Timing chain kit

febi no. 40672

Repl. no. 03C 109 158 A S1

Problems with the timing chain in vehicles with 1.4 TSI engines.

New Version
OE-Number 03C 109 088 E

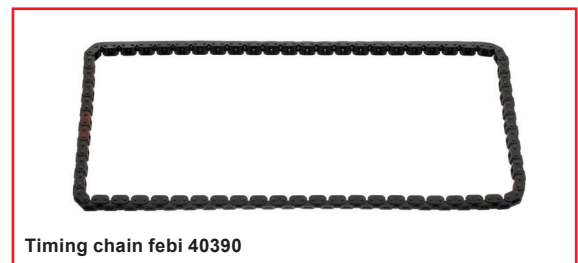
The series manufacturer has reported quality problems with the individual components. Worn tools used during production have left behind metal burrs on the chain links. This leads to premature wear on the chain.

Make sure that you have installed the latest version of the camshaft adjusters. The manufacturer has replaced the camshaft adjusters which have the OE number 03C 109 088 E. The manufacturer explicitly states that the new version must be installed.

Afterwards, carry out a system update of the engine control unit to ensure that the engine runs properly!
